**REPORT TO CORE AREA LIQUID WASTE MANAGEMENT COMMITTEE
MEETING OF WEDNESDAY, OCTOBER 9, 2013**

SUBJECT **DRAFT AMENDMENT NO. 9 TO THE CORE AREA LIQUID WASTE
MANAGEMENT PLAN – CORE AREA WASTEWATER TREATMENT
PROGRAM**

CORE AREA LIQUID WASTE MANAGEMENT PLAN**DRAFT AMENDMENT NO. 9 – SUMMARY****PURPOSE**

FIG. 6.1A
PROPOSED SYSTEM CONFIGURATION

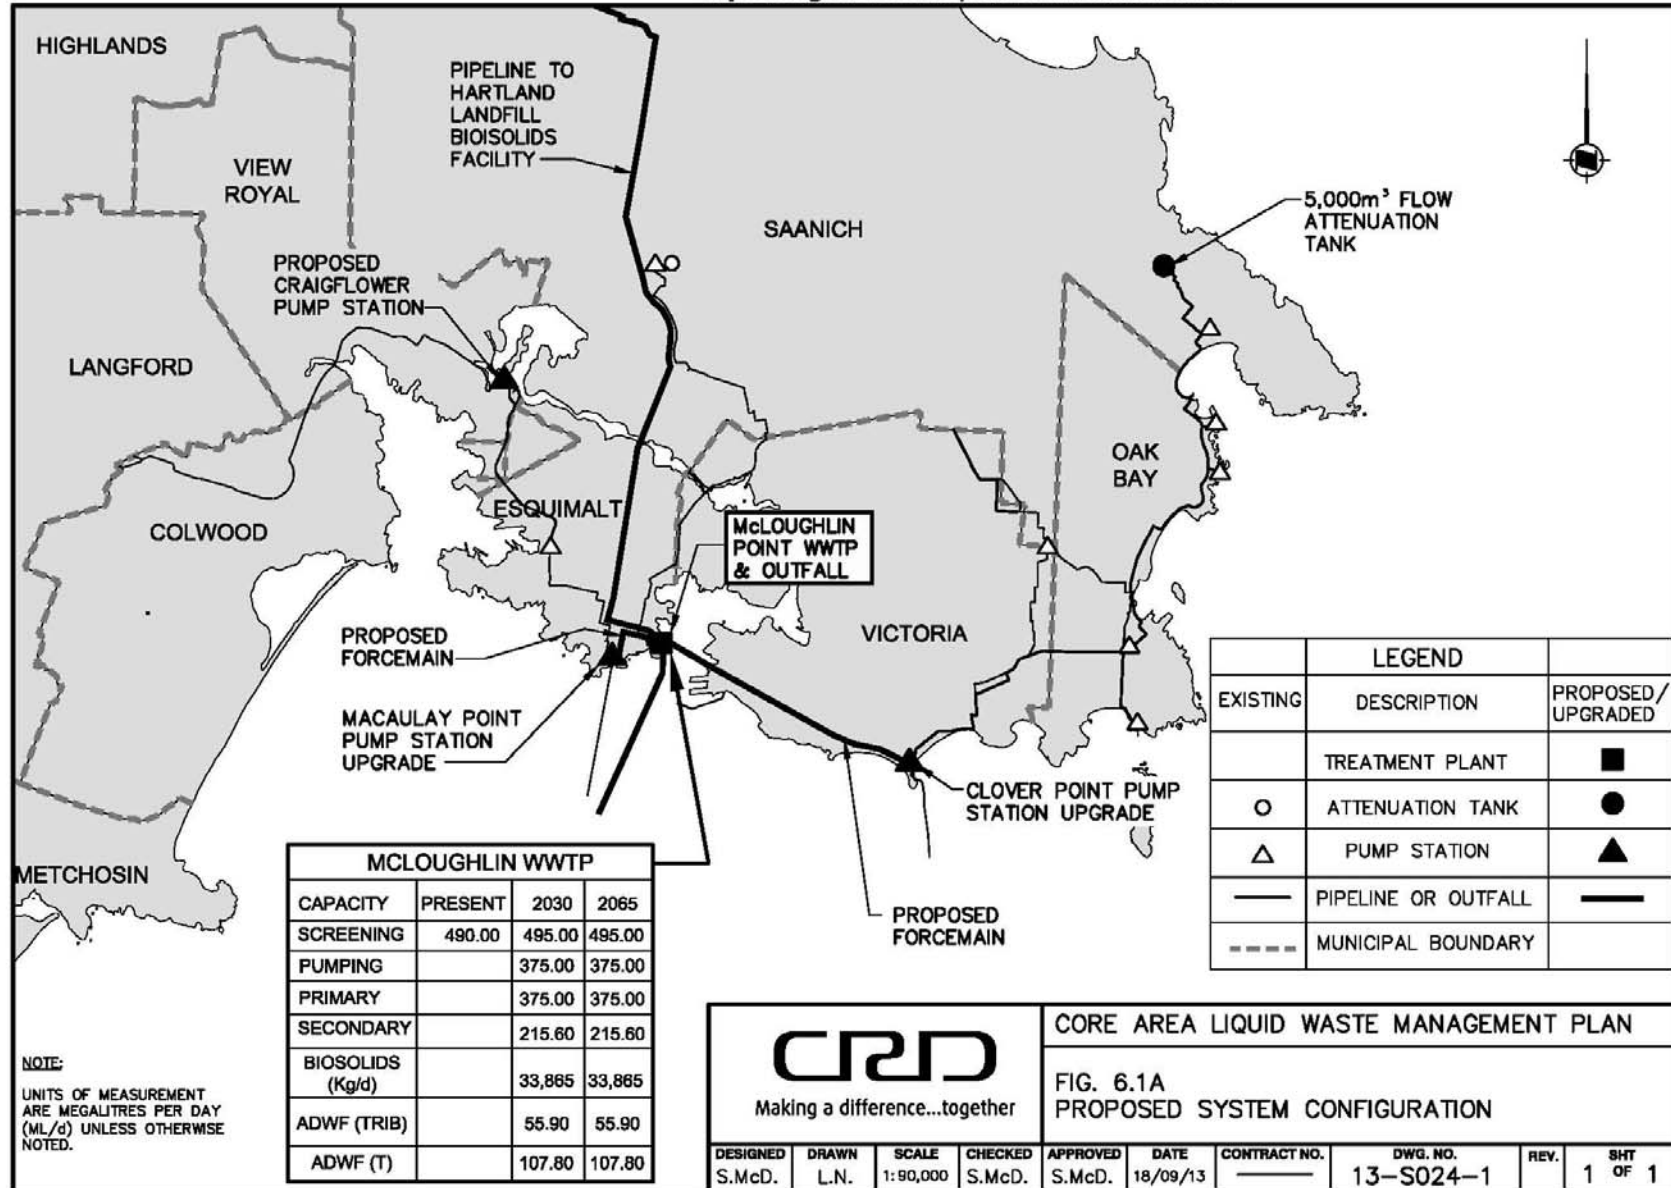
2. The initial storage volume of the proposed Arbutus Road attenuation tank is reduced from 12,000 cubic metres to 5,000 cubic metres.

This attenuation tank is required to enable the transmission of all Saanich East flows to the proposed McLoughlin Point treatment plant. The original 12,000 cubic metre capacity tank was based on a 2004 consultant’s study and was the ultimate size that would be required if inflow and infiltration (I&I) continued to increase beyond 2025. The consultant, Kerr Wood Leidal, has now updated the original study using flow data that has been collected since 2004. The consultant now recommends that a 5,000 cubic metre facility be constructed initially, and that “space should be reserved to double the size of the facility at some time in the future beyond 2030 should I&I increase beyond current levels.” The consultant’s report is attached to this Amendment as Appendix 1.

Amend page 1.2 of Section 1 by deleting *“As indicated in figure 6.1A, a 12,000 m³ wet weather flow attenuation tank will be constructed at Arbutus Road in Saanich.”* and replacing it with *“As indicated in figure 6.1A, a 5,000 m³ wet weather flow attenuation tank will be constructed at Arbutus Road in Saanich.”* The revised figure 6.1A is attached as Appendix 3.
